Appendix A Revised plant layout and elevation plans

**Rosehill Recycled Water Scheme
Revised pipeline alignment, North St
Doc No: PORRW-PL-A-0029 Rev: 1
Date: 16/03/09
Size: A4**

Rosehill Recycled Water Scheme – revised Noise and Vibration Impact Assessment

Appendix D Detailed response - Fairfield City Council

Figure1: Proposed site layout (A0123 – C 0001 – 21 Issue 3)

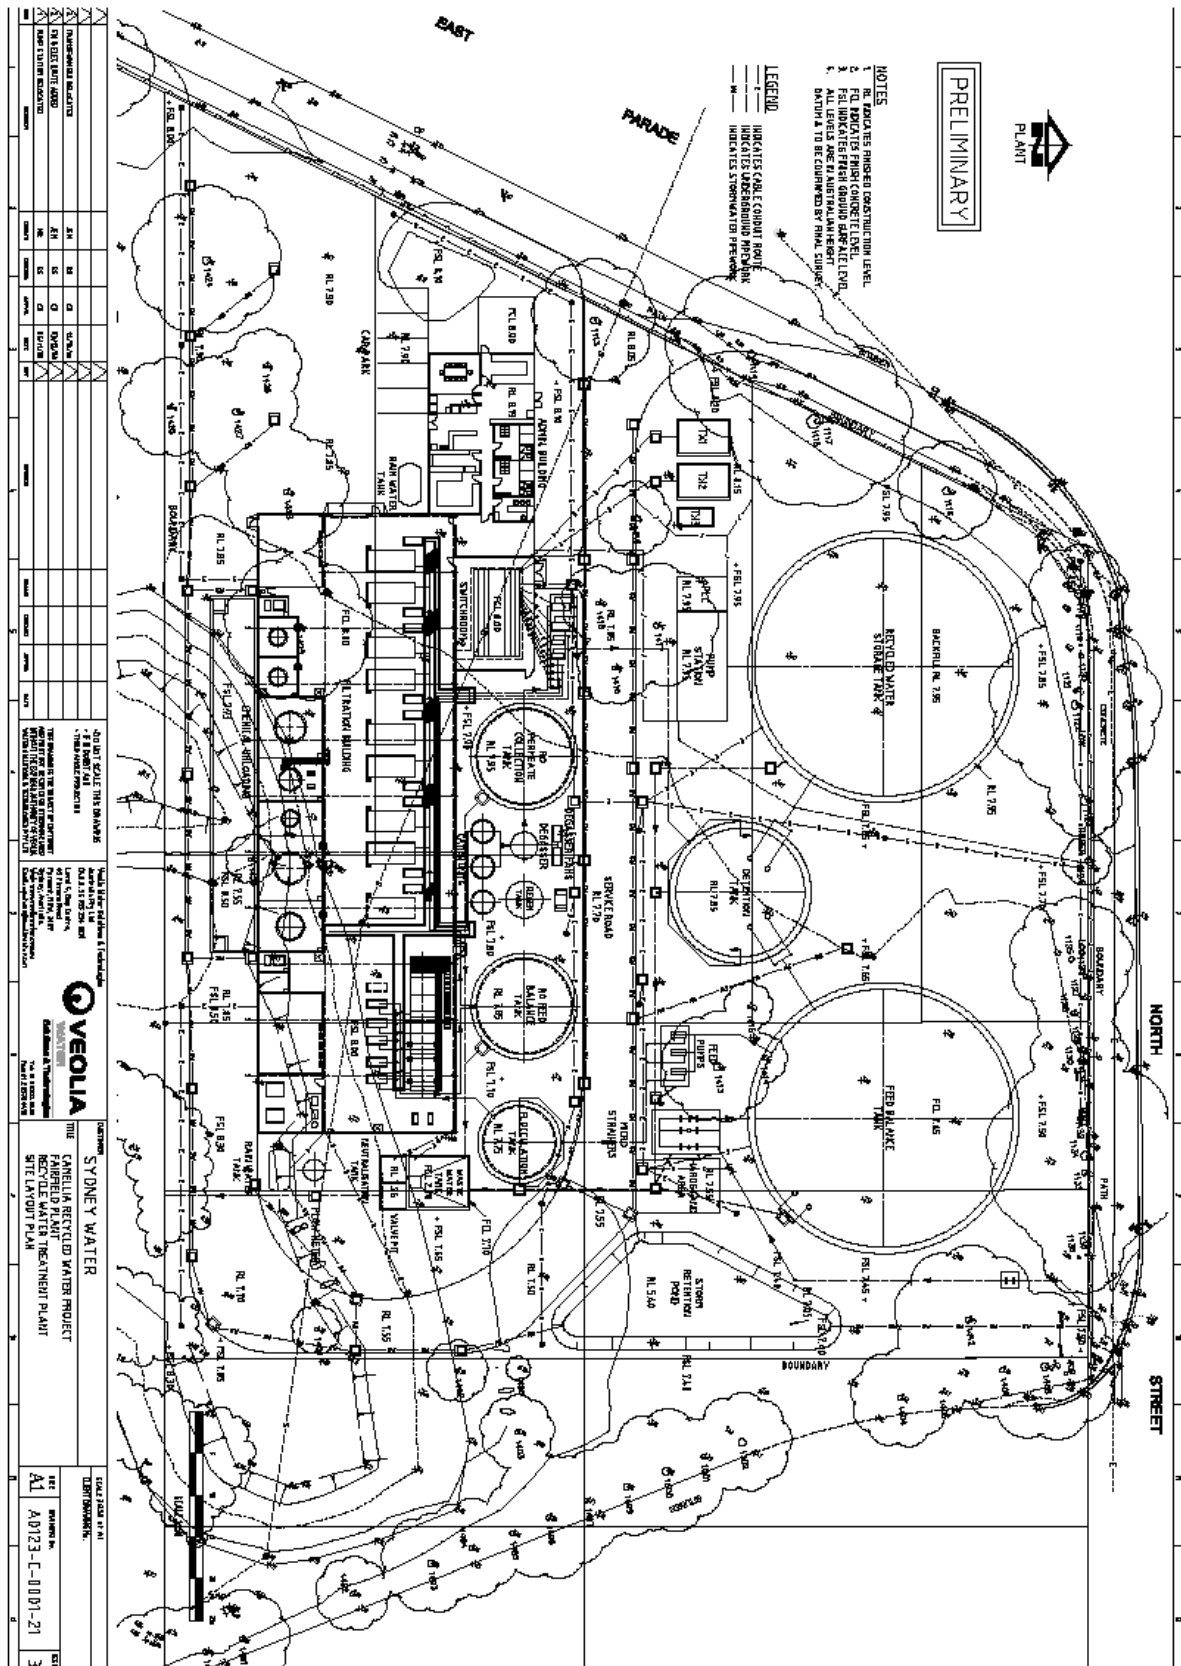
The RWTP site has been redesigned as per drawing A0123 – C 0001 – 21 Issue 3, detailed in enclosed Figure 1. The 3 transformers are located to the south of the 4.8 ML Recycled Water Storage Tank.

- Revised RWTP and transformer location as per enclosed Figure 1.
- 2500 kVa transformer SWL of 79.8 dB(A), 1500 kVa transformer SWL of 76.5 dB(A) and 500 kVa transformer SWL of 69.8 dB(A), provided by Jemena (23 February 2009)
- RWTP operational noise impacts adopted from LT_9197.
- RWTP and 3 transformer simultaneous operation under normal load.
- Nearest receivers located at 70 - 150 metres from the pump station.
- Potential attenuation to received noise levels of 10 dB(A) from the intervening 4.8 ML Recycled Water Storage Tank (6 meter height) at all receivers except Railway Parade.

- A. PORRW-PL-A-0030 Closest residences to proposed plant Rev 0 A4

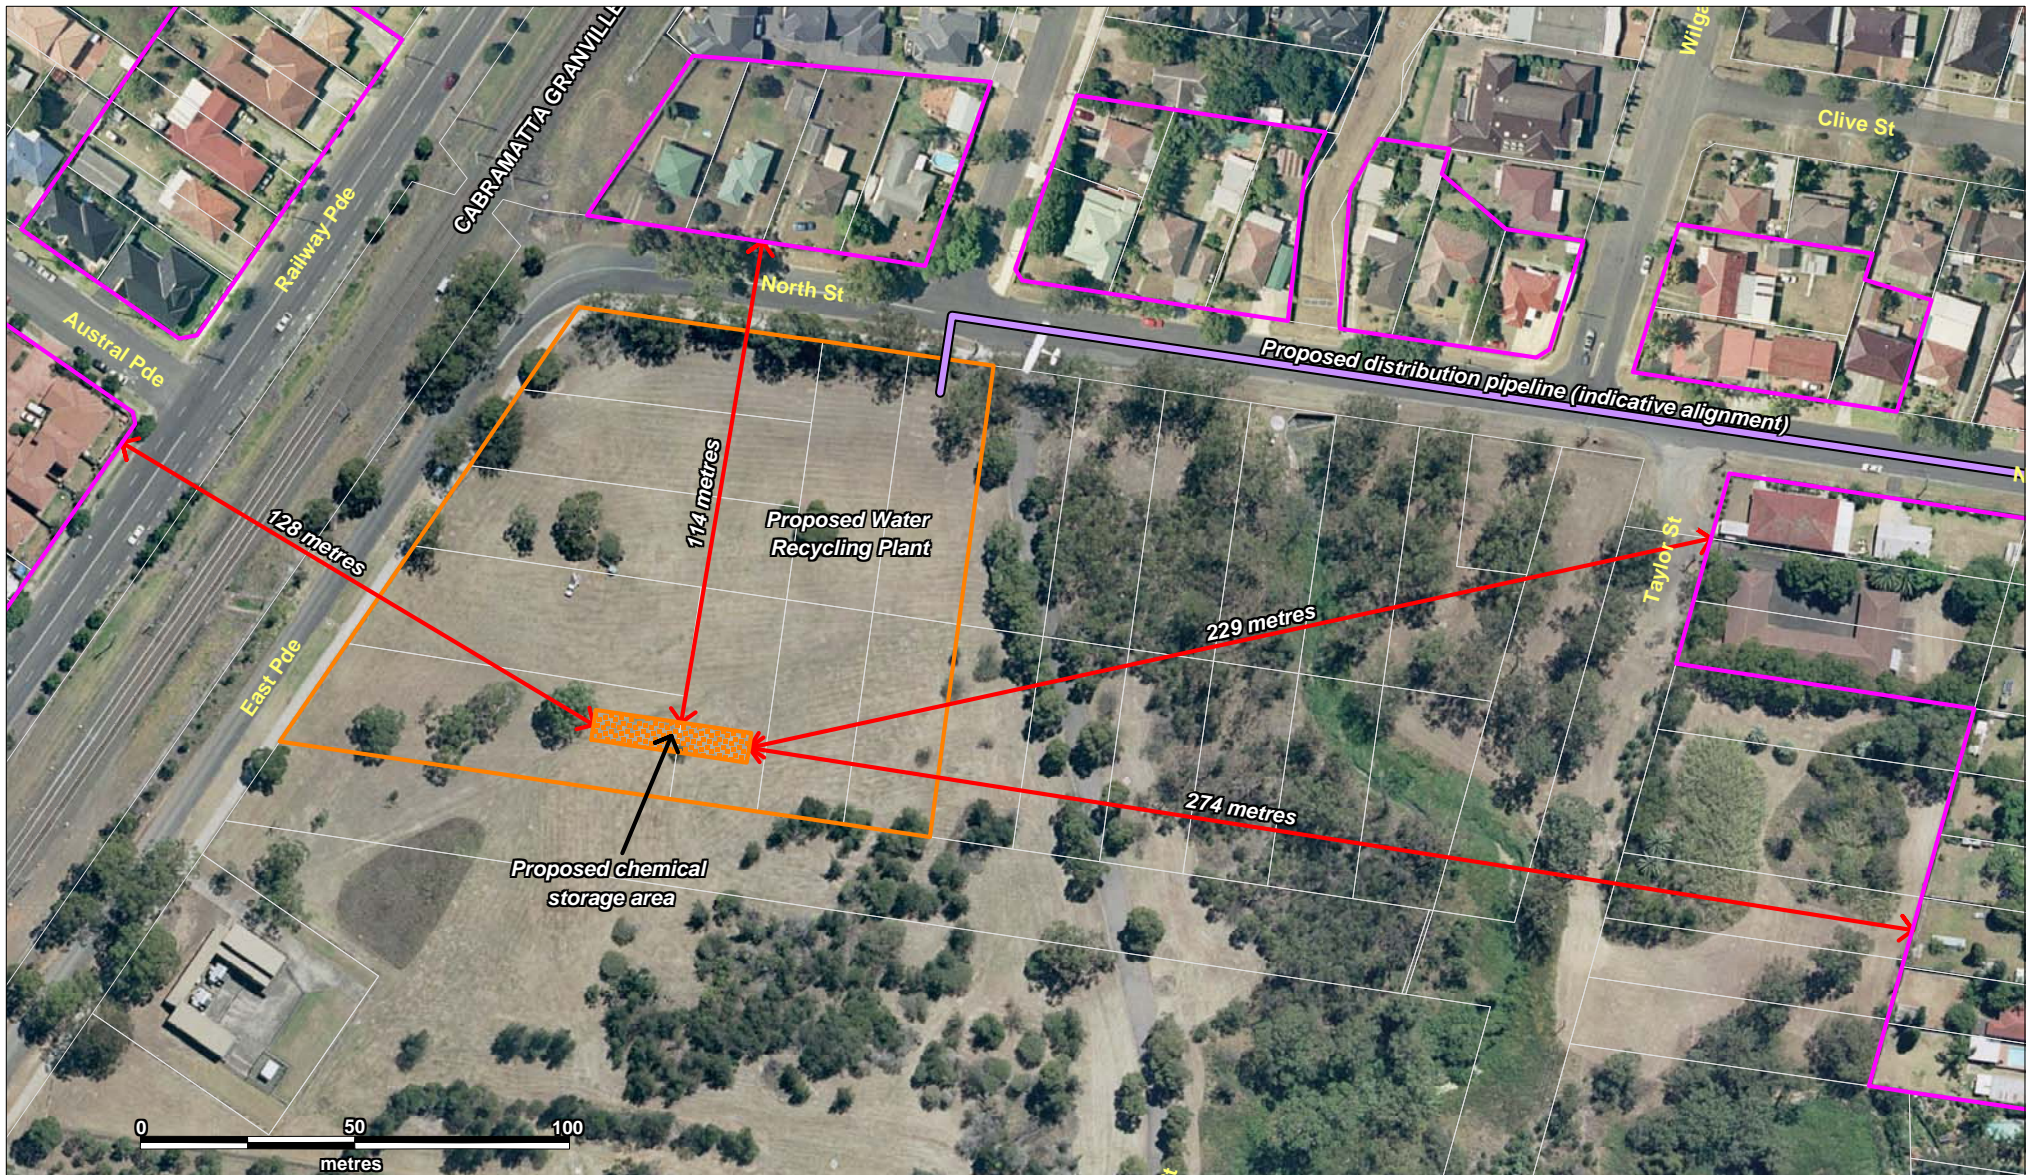
<p>The PHA states that “residential areas surrounding the RWTP are all located at least 100 m from the chemical storage areas”. Council has been unable to verify this statement. Also, as no site plans (to an adequate scale) were submitted with the Environmental Assessment the Council has been unable to confirm that there would be “little or no risk from any hazards” as the proponent asserts. In addition, the measurement should be taken at the closest property boundary, irrespective of where residential dwellings are located.</p>	<p>The closest residences to the chemical unloading and storage area are approximately:</p> <ul style="list-style-type: none"> - 100 metres to the north, - 100 metres to the west, - 400 metres to the south and - 350 metres to the east. <p>Plan PORRW-PL-A-0030 (attached to this attached) shows the location of the proposed chemical storage area from the nearest residences and provides a scale for Council’s information.</p> <p>Given the potential for the release of infrequent release of chlorine gas in insignificant and inconsequential quantities only, these distances provide more than enough clearance, regardless of whether they are measured from the appropriate lot boundary.</p>
